ADDENDUM NUMBER TWO (2)**CATAWBA COUNTY****BLACKBURN RESOURCE RECOVERY FACILITY OPERATOR'S BUILDING****PROJECT NO. 26.00701**

This Addendum Number Two (2) is issued this the 16th day of October 2026, to all parties who hold a set of Bid Documents for the project entitled: **“BLACKBURN RESOURCE RECOVERY FACILITY OPERATOR'S BUILDING”**. This Addendum Number Two (2) shall become part of the Contract Documents and its receipt acknowledged on the bid documents at the time of bidding.

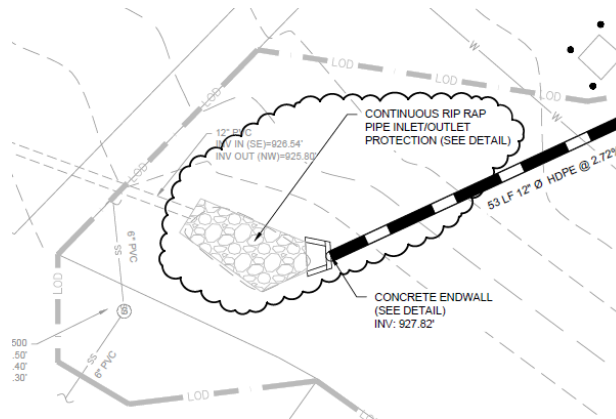
10. There looks to be 8 bollards shown outside the operator's building along with a concrete pad on drawing AS101 as per the screenshot down below, if they are indeed bollards are in the General Contractor's scope of work? If so, can you provide further details?

- a. Bollards surrounding the generator and propane tank are existing site elements and are to remain. See C-001 for coordination with AS101.
